GROWTH MANAGEMENT DEPARTMENT STAFF REPORT
PONTE VEDRA OVERLAY DISTRICT
2/23 2022 Public Meeting
Sawgrass Marriott Cabana - ARC22-1

ARC21-1 Sawgrass Marriott Cabana

Summary of Request: Request for design approval for design changes to the Cabana Beach Club previously approved under ARC2019-16.

03 WEST ELEVATION
1/8" = 1'-0"

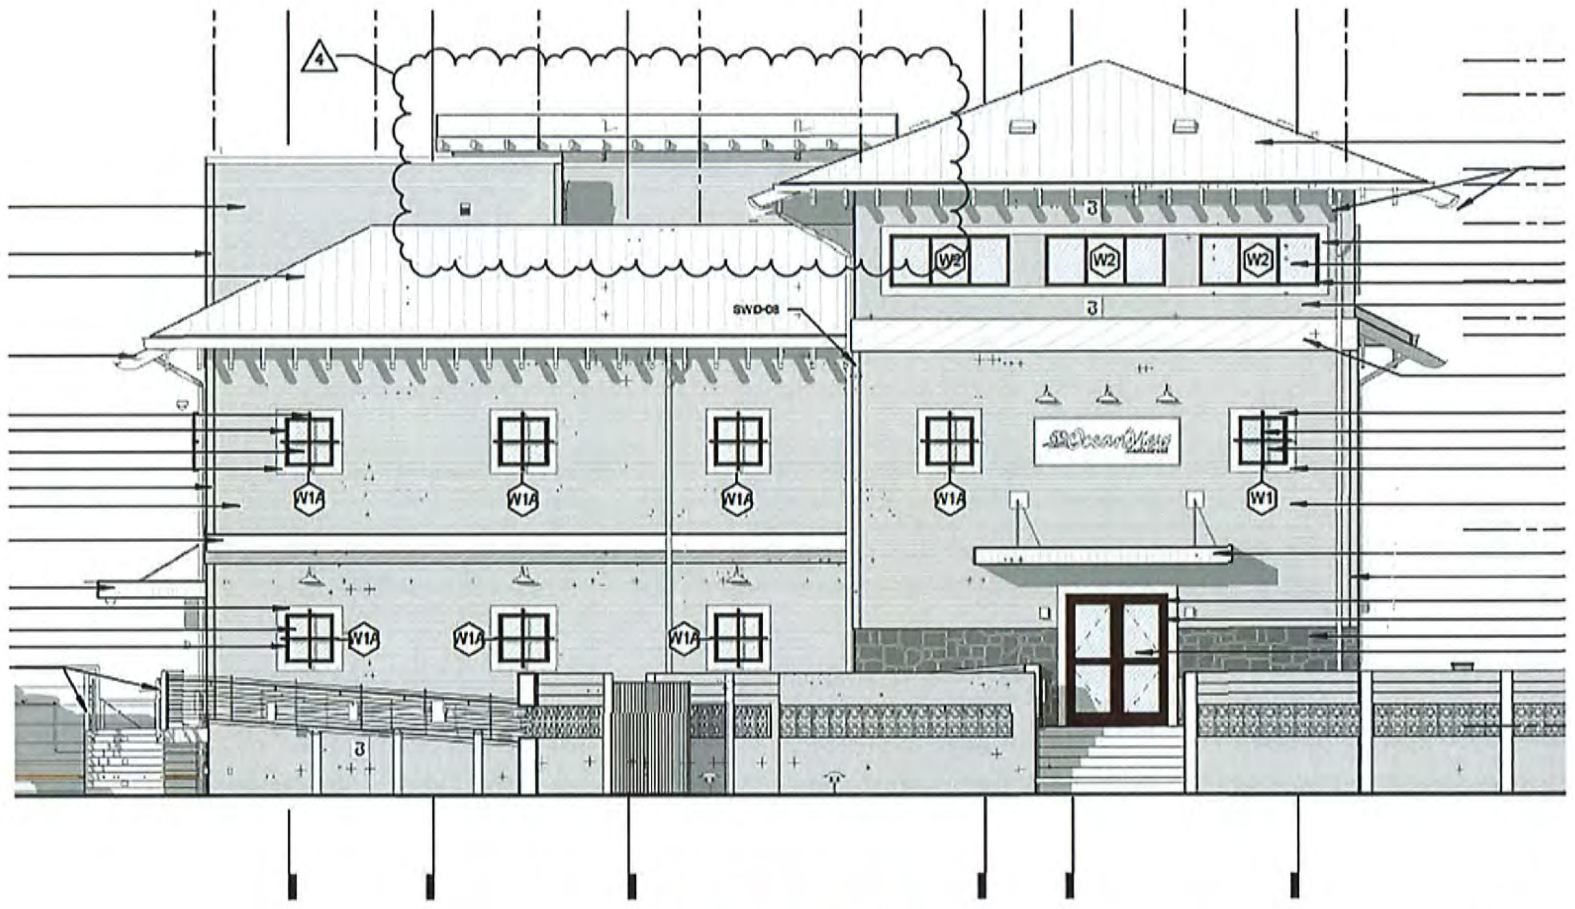
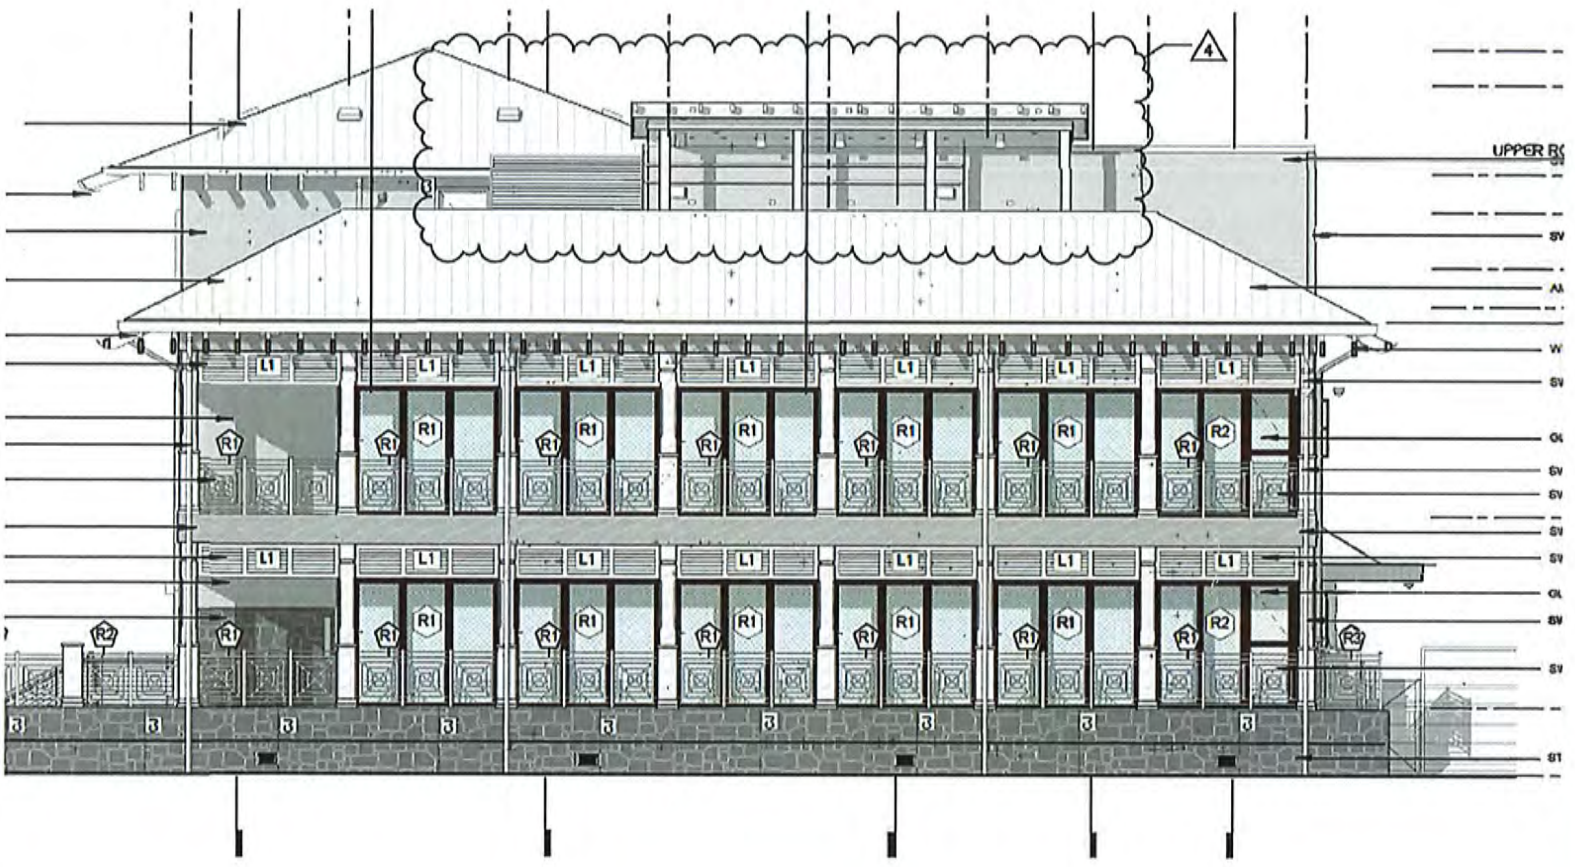
Staff finds that the proposed design revision appears compatible with the existing building design and the regulations of the Ponte Vedra Overlay. Staff notes that the front façade of the roof-top area is not readily visible and does not appear to substantially change the appearance of the building from Ponte Vedra Boulevard. The rooftop area may be more readily visible from the beach side. Staff has requested that the applicant provide more detailed renderings to best depict the appearance of the roof-top area.
